Subj: Proposed State Highway Encroachment on Training Areas AA, AB, and AC

FACT SHEET

Subject: JACKSONVILLE THOROUGHFARE PLAN (NEW PROPOSED PLAN)

**JACKSONVILLE  
 THOROUGHFARE PLAN**  
 APRIL 25, 1963

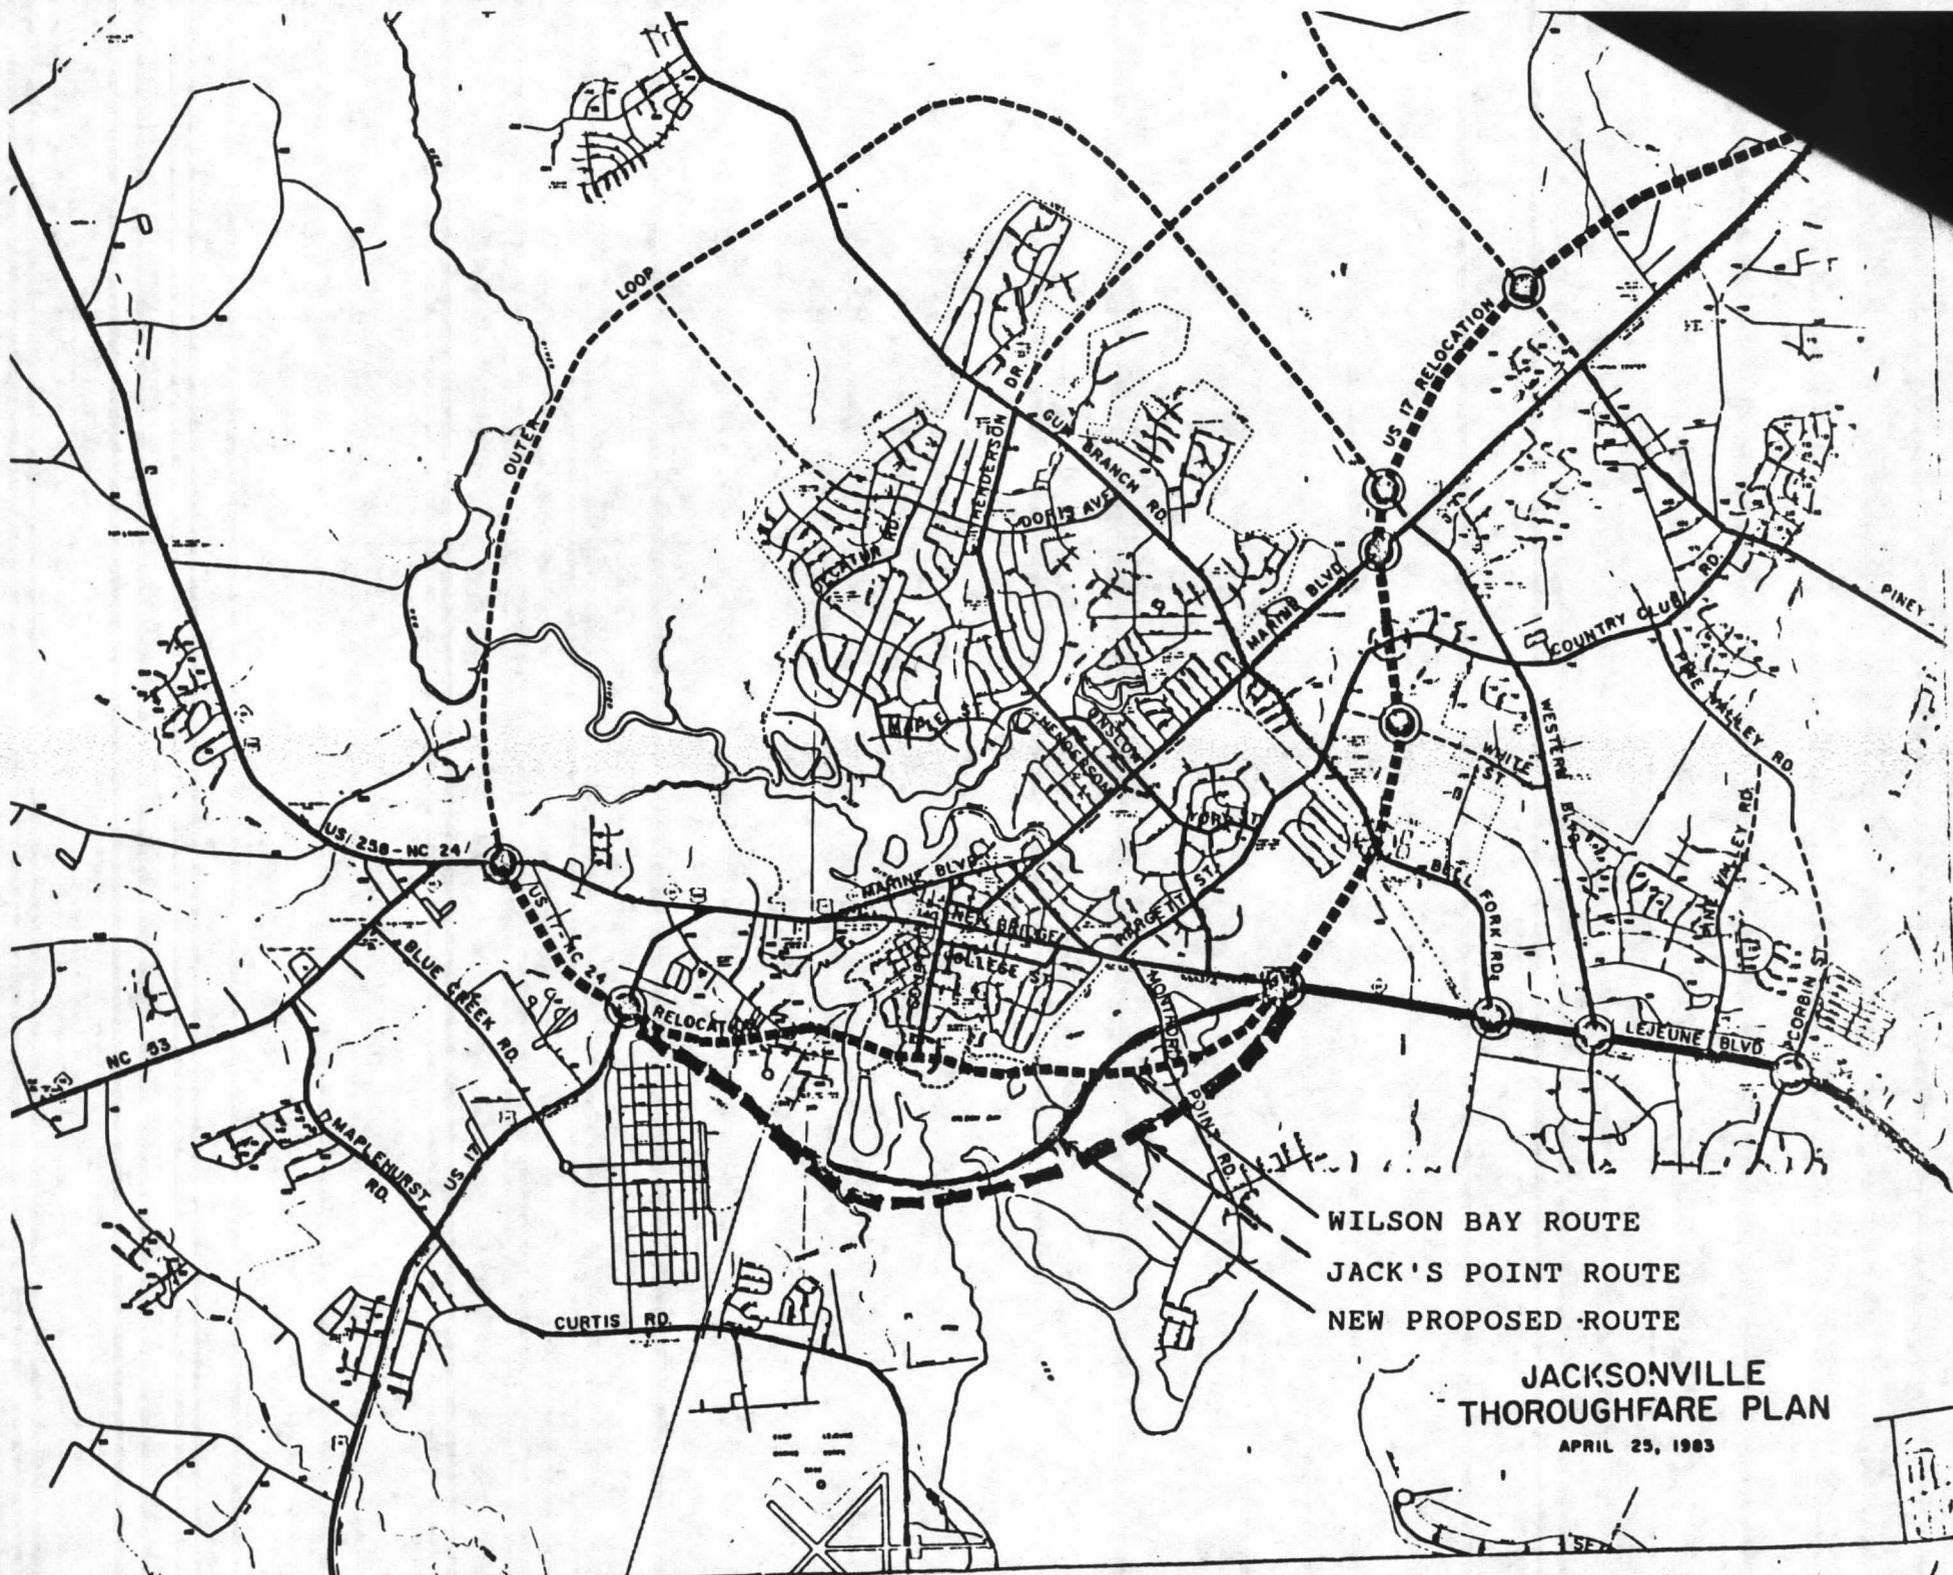
Certain problems become obvious when reviewing the Jack's Point proposed route. The new proposal presents the identical set of problems for Camp Geiger as does the Jack's Point route.

A. Driver Training School (DTS) loses a portion of one of its Training Areas (Coordinates 753470 )

B. FMFLANT NBC School's Gas Chamber and associated trails (Coordinates 757465 ) would be displaced.

C. The Camp Geiger/MCAS (H) Sewer Treatment Facility would be isolated. (Coordinates 762463).

Camp Geiger's CONCERNS would be ALLEVIATED if the proposed route were West of BEINSON CREEK until PAST THE Sewage Treatment Facility

4. Implementation of the Wilson Bay Alignment, as shown in reference (b), would minimize the adverse effects mentioned above, and would be preferred by this command.

A. DTS could operate with little degradation by the loss of the hard surface area.

B. FMFLANT NBC School's Gas Chamber and associated training trails would have to be rebuilt elsewhere. Areas exist in the Camp Geiger/MCAS(H) New River area.

C. An overpass or suitable substitute would be required to provide access to the Camp Geiger/MCAS(H) New River Sewage Disposal Facility.
